# PERMIT

SEWAGE DISPOSAL SYSTEM

SUBDIVISION William Contrivance LOT 3 ROAD 9435 Lovat Road

REPAIR - PURPOSE - SEPTIC SYSTEM HAS FAILED.

INDICATE NORTH - NAME ADJOINING ROADWAY AS BASE LINE.

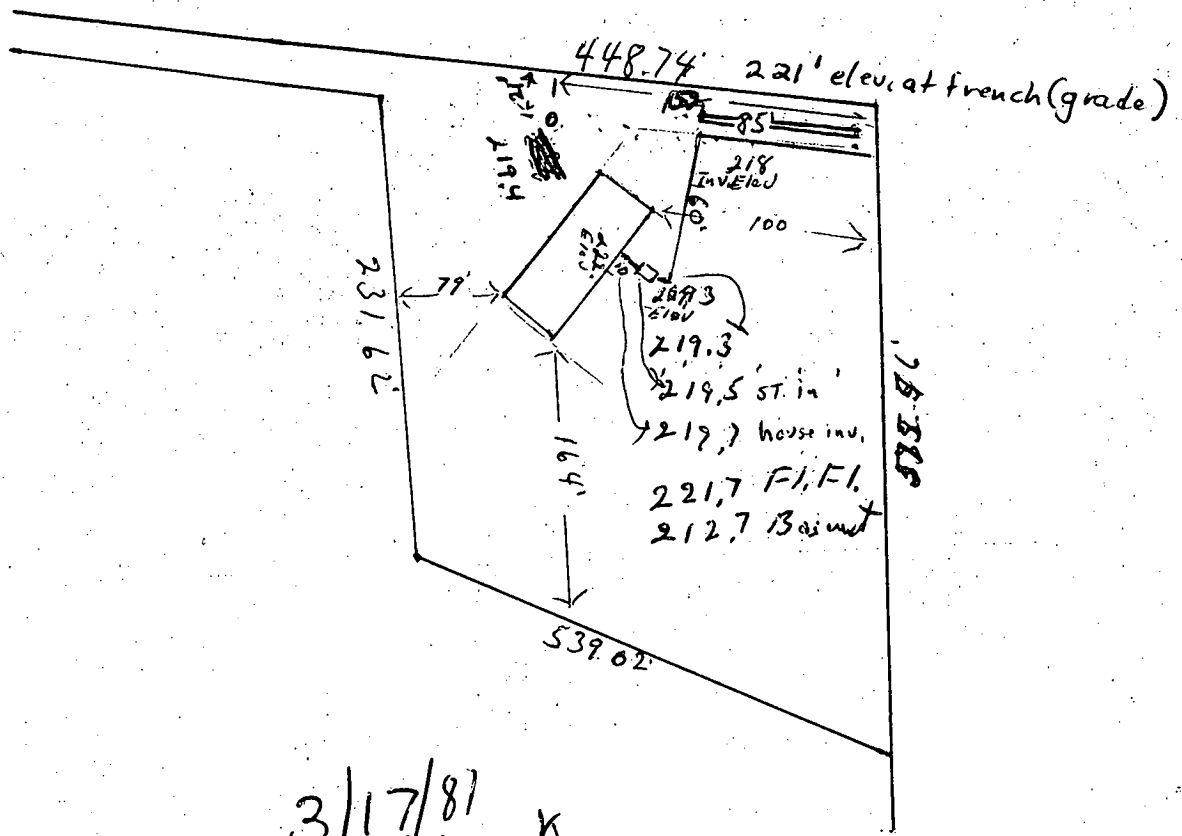
REMARKS: 1/14/81 Visit site E.F. & Ron Herr. O.K'd placement of house no closer than 100 ft. to rear lot line ne. Dywell to be 10 ft off left sideline & ~90 ft from rear lot line (stay 20 ft. off of left rear corner of Bldg) S.T.S.

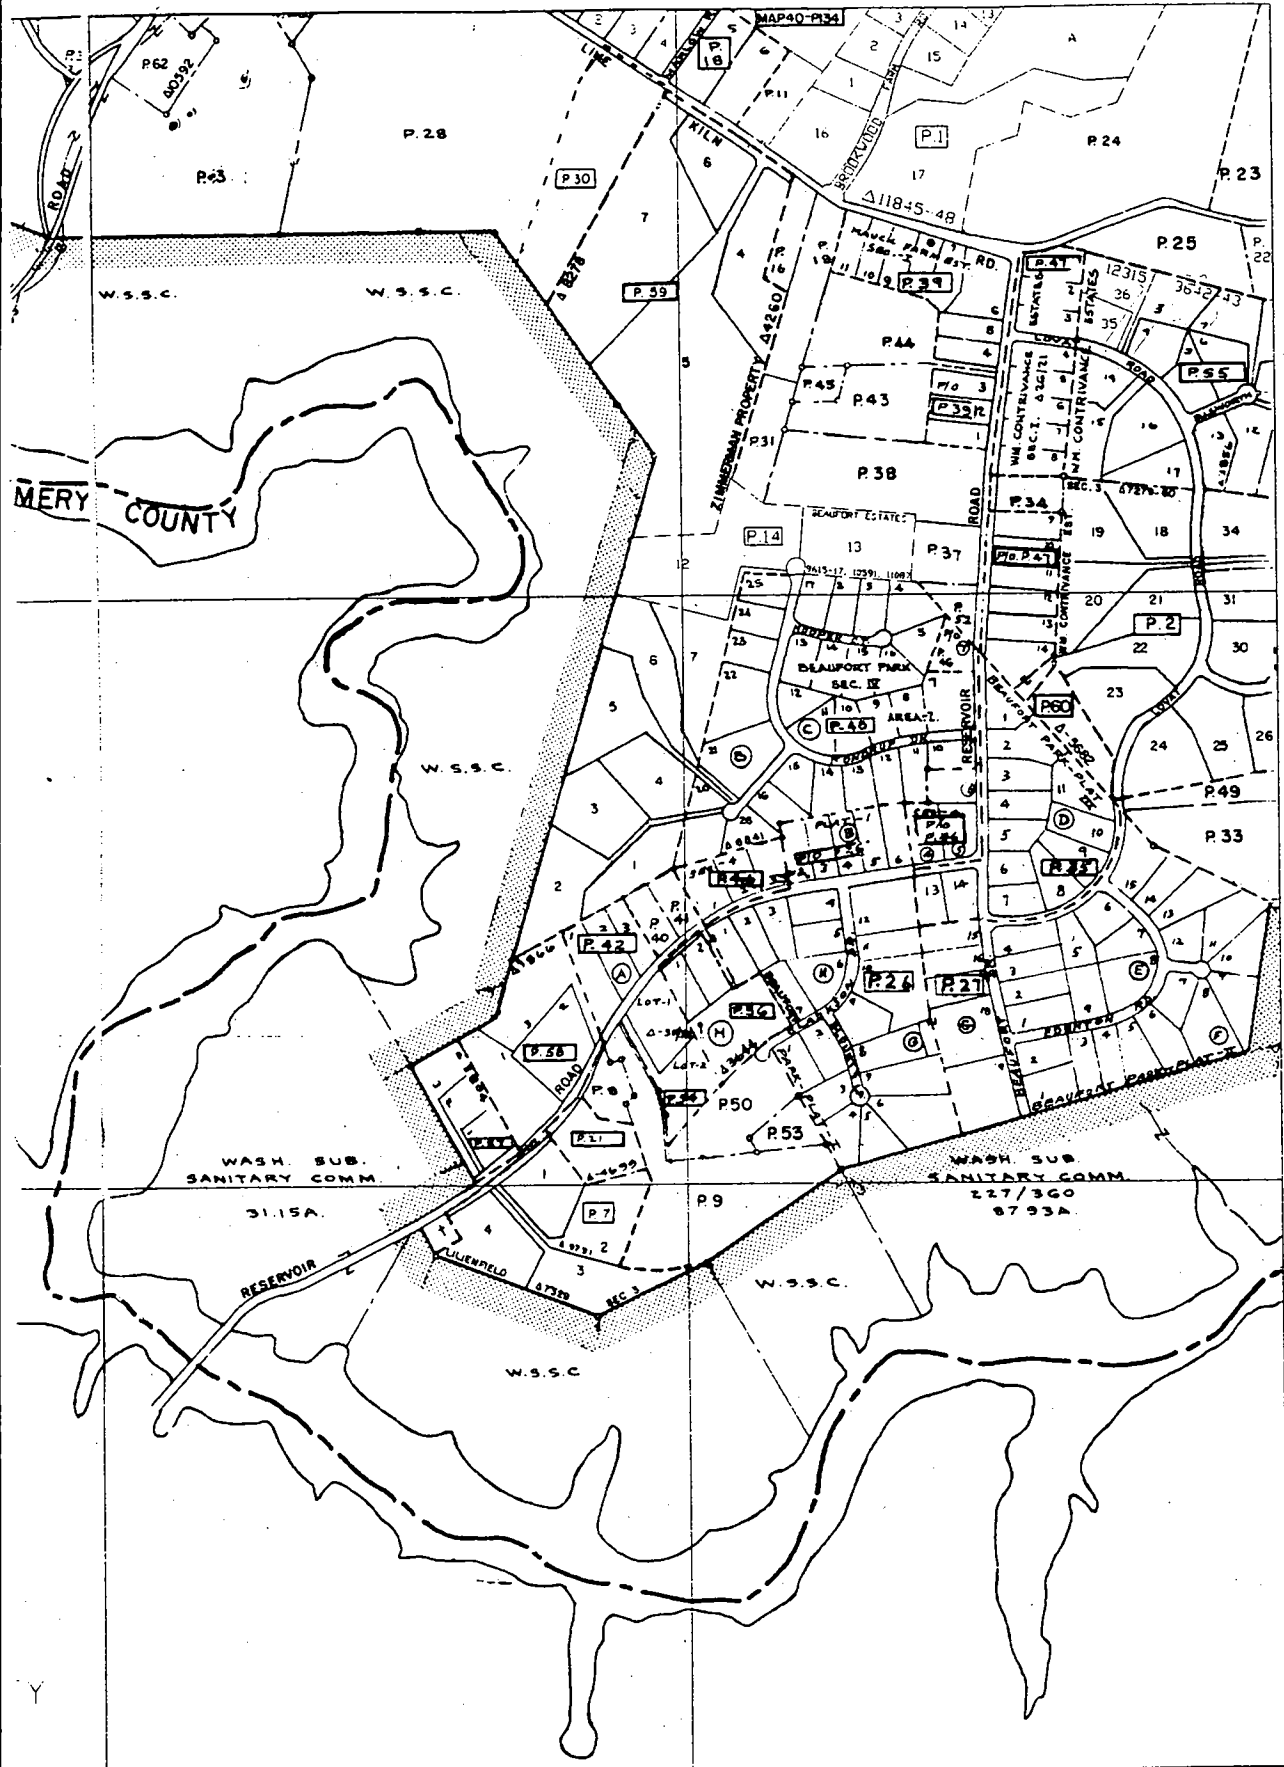
10-12-94  
 Proposed screened porch above existing deck will have no impact to existing well or septic. OK VAT to proceed.
